UNITED STATES PATENT AND TRADEMARK OFFICE

APPLICATION NO.	FILING DATE	FIRST NAMED INVENTOR	ATTORNEY DOCKET NO.	CONFIRMATION NO.
10/708,249	02/19/2004	Walter Uebelacker	87072/1	2248
27717	7590	05/03/2007		
SEYFARTH SHAW LLP 131 S. DEARBORN ST., SUITE2400 CHICAGO, IL 60603-5803				
			EXAMINER KHOLDEBARIN, IMAN K	
			ART UNIT 3737	PAPER NUMBER
			MAIL DATE 05/03/2007	DELIVERY MODE PAPER

Office Action Summary

DETAILED ACTION

Fig. 3. A schematic drawing of the various shock-wave sources currently in clinical use.

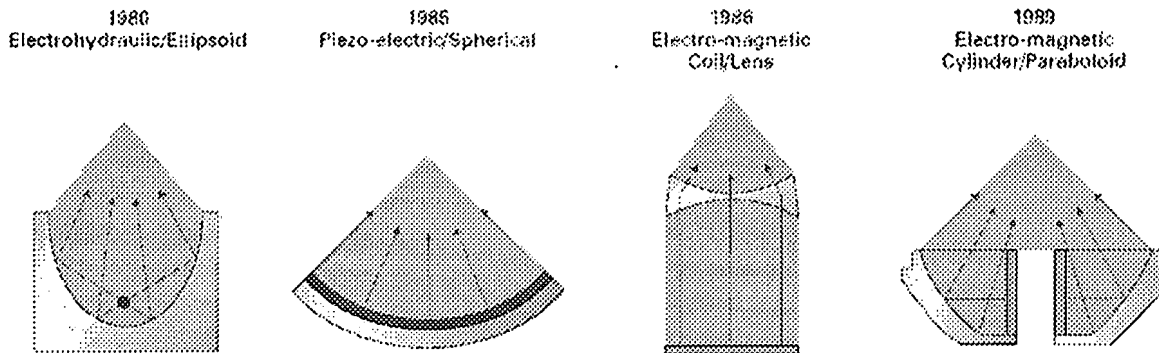
Claim 1-27 are rejected under 35 U.S.C. 101 because the disclosed invention is inoperative and therefore lacks utility. Based on the specification disclosed [0012 and 0013] the task of the present invention is to optimized the interaction of the shock wave with the tissue of a subject being treated so as to achieve the best clinical result. Applicant disclosed that this task is accomplished by using high-energy shock waves are generated by electro hydraulic, electro magnetic or piezoelectric means, but not focused into a focal point. Instead, the shock wave is reflected or refracted in such a way that a plane wave or flat wave is emitted from the source. Furthermore applicant discloses that the structure of the present apparatus comprises of a reflector housing, a parabolic reflector disposed in the housing and energy source [0015, line 1-4]. And, in an embodiment, the energy source may have a propagation point centered approximately at the focal point of the parabolic reflector [0016]. In view of one ordinary skill in the art at time of this invention was made studies show that reflection of the waves emitted from the energy source based on the location disclosed by the applicant will not result in a plane wave or flat wave format. Please see the following reference.

Re Claim 1, 4, 17, 18: Wilbert discloses a therapeutic shock wave device and method comprising a reflector housing, a parabolic reflector and an energy source and coupling member (See Paragraph 1, 3 and Fig. 3).

Re Claim 6 and 7: Wilbert disclose that the energy source is an electro-hydraulic source, (See paragraph 13, "titled principle of shock wave generation" and Fig.3a).

Walbert teaches method of using electro-hydraulic, electromagnetic or piezoelectric and reflecting the shockwave from a parabolic reflector, (See Fig. 3).
